**SERVICE BULLETIN**

**APPLICABILITY:** 2012MY Impreza 2.0L Models

**NUMBER:** 06-56-16

**SUBJECT:** New Rear Wheel ABS Sensor Replacement Parts

The illustrations below show the differences between the original (OLD) and the NEW configurations.

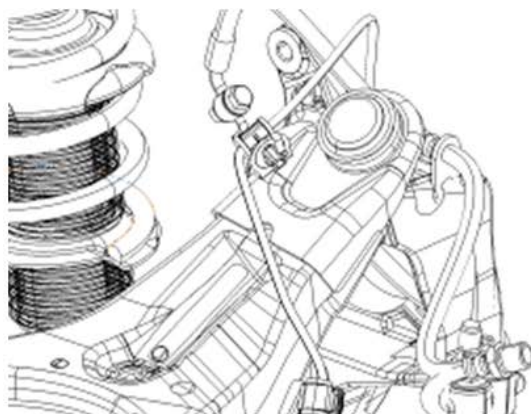
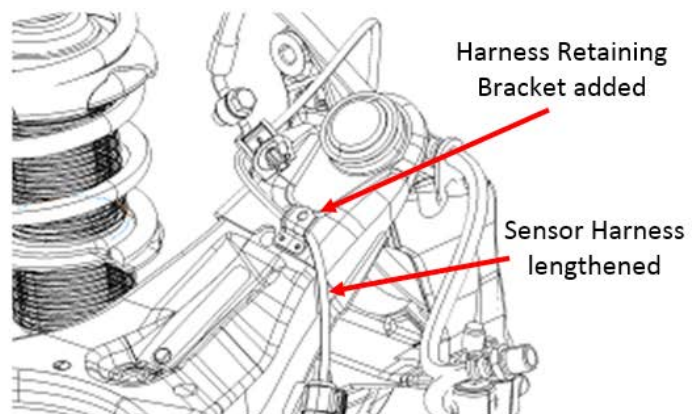
This bulletin replaces TSB 06-42-12 dated 01/19/12. This bulletin announces a revised procedure and parts change information to follow when replacement of a rear ABS wheel speed sensor is required on a limited number of 2012MY Impreza vehicles which fall within the specific VIN ranges listed below. Design changes were made to the original sensor and the upper rear arm for these vehicles. The sensor harness length has been extended and a retaining bracket added to the rear upper arm to secure the harness and keep it from contacting other related parts.

**IMPORTANT NOTE:** These new ABS rear wheel speed sensors are not interchangeable with the old rear arms (and vice-versa) as insufficient clearance with related parts and / or possible disconnection of the sensor may result.

Whenever replacing an ABS rear wheel speed sensor assembly on a vehicle within the affected VIN range supplied above, the sensor AND the rear upper arm assembly for the affected side must be replaced as a set following the procedure in the applicable Service Manual.
